E/ECE/324
E/ECE/TRANS/505 } Rev.1/Add.35/Rev.1/Amend.1

Addendum 35: Regulation No. 36

Revision 1 - Amendment 1

UNIFORM PROVISIONS CONCERNING THE APPROVAL OF LARGE PASSENGER VEHICLES WITH REGARD TO THEIR GENERAL CONSTRUCTION

"5.7.4. Access to escape hatches

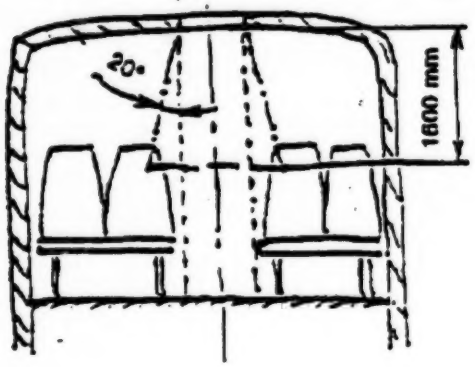
Paragraph 5.7.4., amend to read:

5.7.4.1. Except in the case of Class I vehicles, at least one escape hatch shall be located such that a four-sided truncated pyramid having a side angle of 20° and a height of 1,600 mm touches part of a seat or equivalent support. The axis of the pyramid shall be vertical and its smaller section shall contact the aperture area of the escape hatch. Supports may be foldable or movable provided they can be locked in their position of use. This position shall be taken for verification.

5.7.4.2. When the structural thickness of the roof is more than 150 mm, the smaller section of the pyramid shall contact the aperture area of the escape hatch at the level of the outside surface of the roof."

"Figure 11

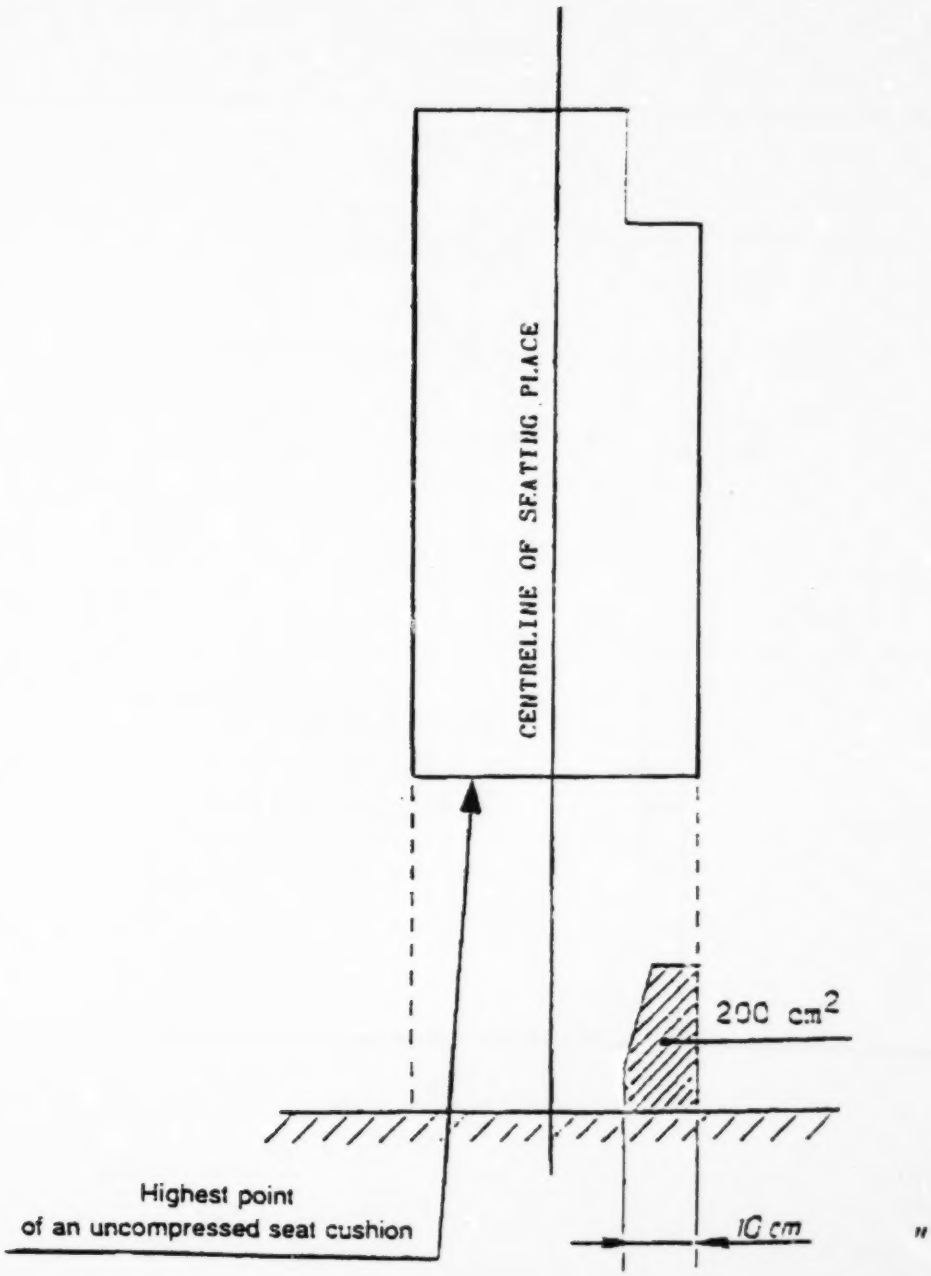
"5.7.8.6.2.3. Intrusion of a conduit (e.g. for hot air) situated in the lower part of the space in question, adjacent to the sidewall of the vehicle, of a cross-sectional area not exceeding 200 cm^2 and having a maximum width of 10 cm (see annex 3, figure 11)."

Annex 3, figure 11, replace by the following figure:

PERMITTED INTRUSION OF A CONDUIT
(see paragraph 5.7.8.6.2.3.)

Figure A

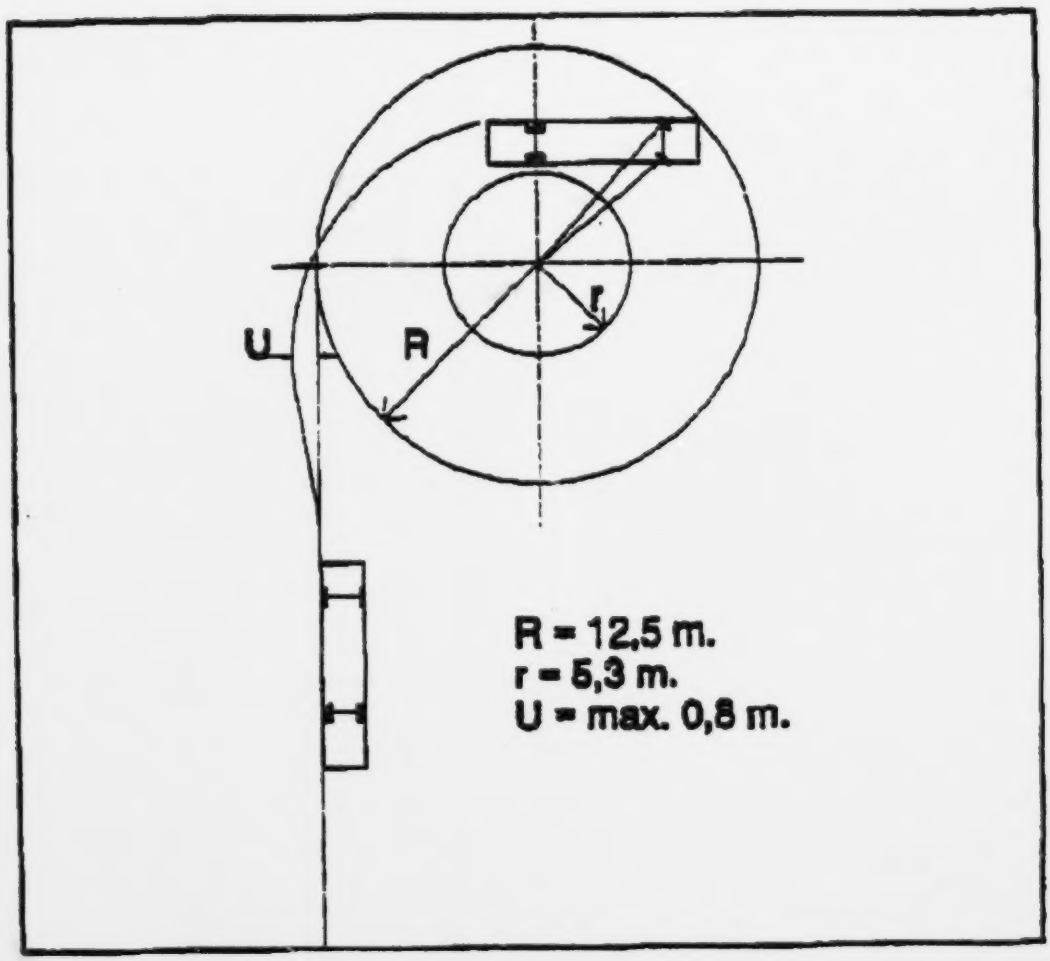
"5.10.1. The vehicle shall be able to manoeuvre on either lock inside a circle of 12.5 m radius without any of its outermost points projecting outside the circumference of the circle.

5.10.2. When the outermost points of the vehicle are moving on either lock on a circle of 12.5 m radius the vehicle shall be able to move within the limits of a circular track 7.2 m wide (see annex 4, figure A/B)."

Annex 4, figures A and B, replace by the following figures (figure C being deleted):

the plane. When the vehicle moves from a straight line approach into the circular area described in paragraphs 5.10.1. and 5.10.2. above, no part of it shall move outside of this vertical plane by more than 0.8 m (see annex 4. figure A) in the case of a rigid vehicle, or by more than 1.2 m (see annex 4, figure B) in the case of an articulated vehicle."
